VISUAL CONTRAST RATING WORKSHEET

Date: 8 JULY 2008
District: KANAB
Resource Area: SCENIC HWY 89
Activity (program): TRANSMISSION LINE

1. Project Name: GARKANE EIS
2. Key Observation Point: (#1) US 89 - NORTH OF HATCH
3. VRM Class: III
4. Location
   Township: 36 S
   Range: 5 W
   Section: 10
5. Location Sketch

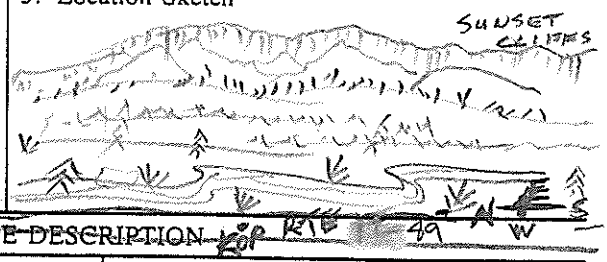
STRONG form contrasts as it approaches US 89 scenic highway, dominating the view of southbound passengers. Silhouette effects would be obvious to casual viewer

(1) edge feathering to reduce line + color contrasts from transmission line cleared areas:

(2) preserve low-lying vegetation within line safety area to reduce line + color contrasts

(3) topographic hiding wherever possible within ROW to reduce form contrasts

5. Location Sketch

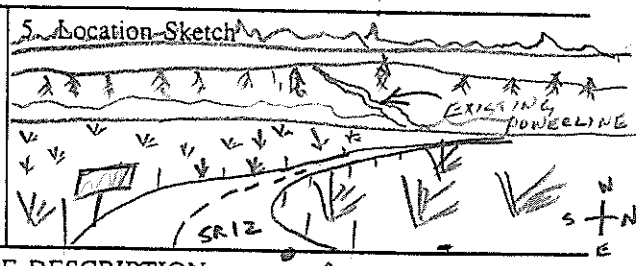
Existing surface disturbances would reduce impacts of new disturbance, the viewing distance to new ROW T line would mitigate some line, form, color, texture impacts along SR 12. Probably attract attention, but not dominate the view

edge-feathering, irregular thinning and low, visually debris left on distant ROW cut would reduce impacts on the forested slope
